ALAMEDA COUNTY
HEALTH CARE SERVICES

Subject: Fuel Leak Case No. RO0002585, Wente Winery, 5565 Tesla Road, Livermore, CA –
Work Plan Approval

Subject: Fuel Leak Case No. RO0002585, Wente Winery, 5565 Tesla Road, Livermore, CA

Revised Hand Auger and Depth-discrete Groundwater Sampling Locations Figure

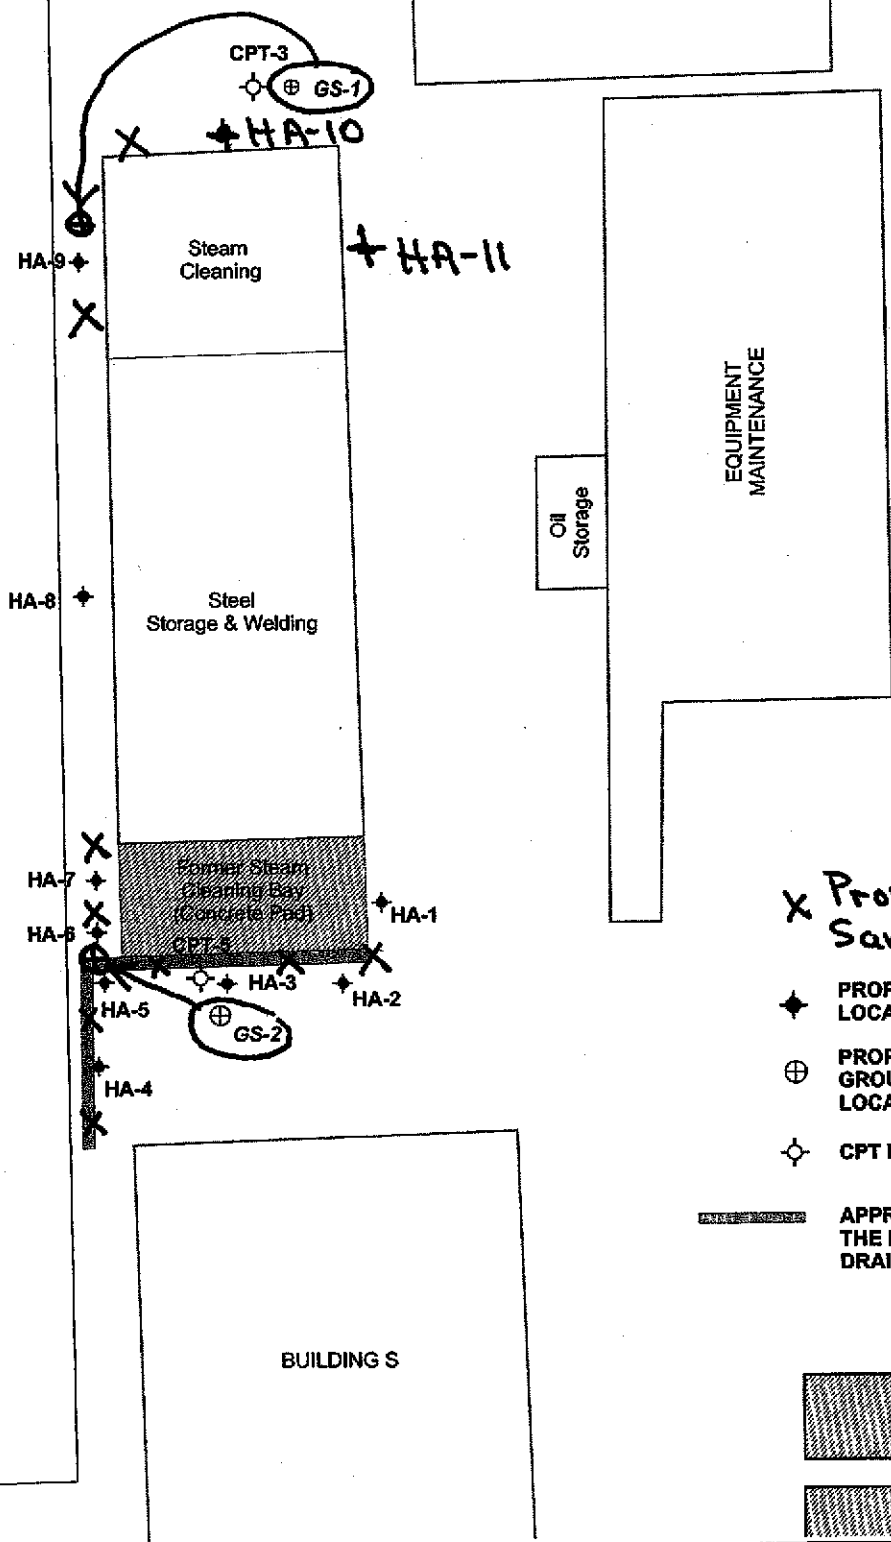
1. **Proposed Depth-discrete Groundwater Sampling from GS-1.** The Response to Comments/Work Plan proposes the collection of grab groundwater samples from intervals of 11 to 16 and 39 to 44 feet bgs at proposed location GS-1. We also request that a grab groundwater sample be collected from a depth of 58 to 63 feet bgs at proposed location GS-1. We request that proposed location GS-1 be moved to a location downgradient from the Steam Cleaning Area as shown on the attached "Revised Hand Auger and Depth-discrete Groundwater Sampling Locations Figure."

2. **Proposed Grab Groundwater Sampling from GS-2.** The Response to Comments/Work Plan proposes the collection of grab groundwater samples from intervals of 19 to 24 and 56 to 61 feet bgs at location GS-2. We concur with the proposed depth intervals for the depth-discrete grab groundwater sampling in GS-2. We request that proposed location GS-2 be moved to a location downgradient from the former unlined drainage ditch and Steam Cleaning Bay as shown on the attached "Revised Hand Auger and Depth-discrete Groundwater Sampling Locations Figure."
